REMARKS

IN THE DRAWINGS

Please replace the drawing sheet with Figures 9, 10 and 11 with the attached replacement sheet for these figures, in which the AGC Block Diagram of Figure 11 has been renumbered as element "116".

FIG. 11

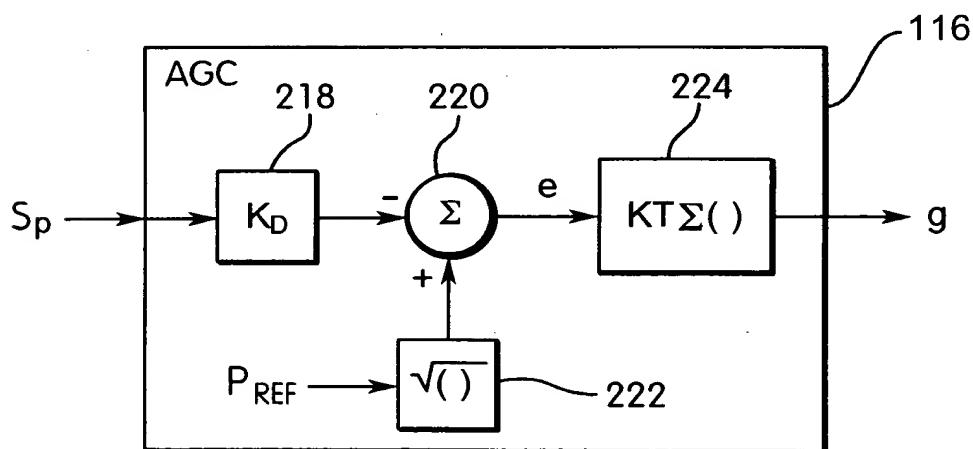
The Office Action (§ 7) objects to Figure 11, because the AGC Block Diagram is numbered as item 112, and should be numbered as item 116. In response, Applicants have hereby amended Figure 11 to change the numbering for the AGC Block Diagram to item 116.
